**Floodplain meadows Partnership response to Task 4 outlined in the document
'Oxford Flood Alleviation Scheme
SCOPE OF WORK FOR THE FLOODPLAIN MEADOWS PARTNERSHIP'
6 April 2017**

Response from FMP

Figure 1. Soil-moisture-release curve for the upper soil horizon of Hinksey Meadow. The curve represents the mean values from six separate cores (sampled from across the meadow,) which were analysed on a sand-table. The error bars represent one standard error of the mean.

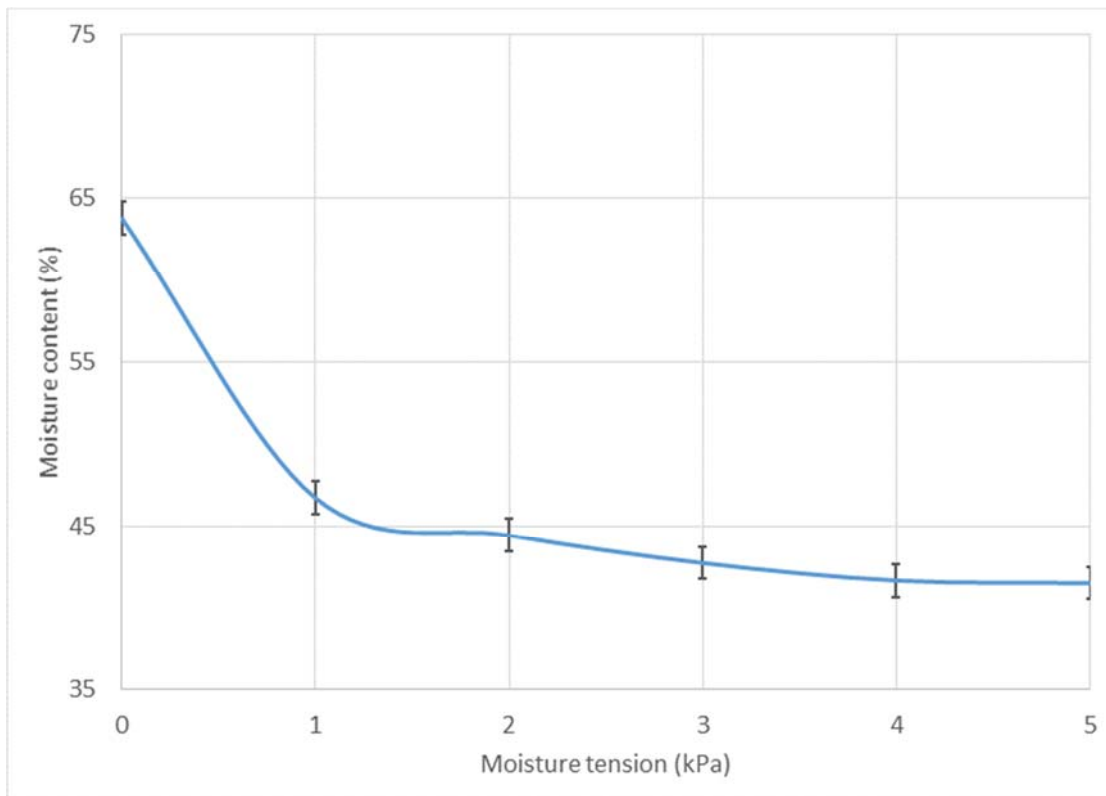
To help inform this deliberation, we collected six undisturbed soil cores (each 100 cm³) from the surface horizon of the meadow to characterise how freely draining the soil is and therefore how the vegetation is likely to respond to water-table fluctuations. We analysed these cores on a sand-table and have generated a soil-moisture-release curve (Figure 1,) which demonstrates the upper soil layer to be very porous, free draining and well structured. We have not investigated the full profile in this way (as that would have involved digging pits in a sensitive area,) but the implication is that the root zone of the meadow is likely to be connected to and responsive to the water regime of the underlying gravel aquifer, especially as the alluvial thickness in some parts of the meadow is expected to be approximately 0.5 m (Richard Winstanley *pers. comm.*, 24/03/17).

There is unlikely to be a discontinuity because the alluvium is relatively shallow (<1 m deep) at the site and its soil-moisture release curve shows it to be very well structured. It is therefore likely that the root zone will be directly affected by any change to the piezometric head in the gravel aquifer.
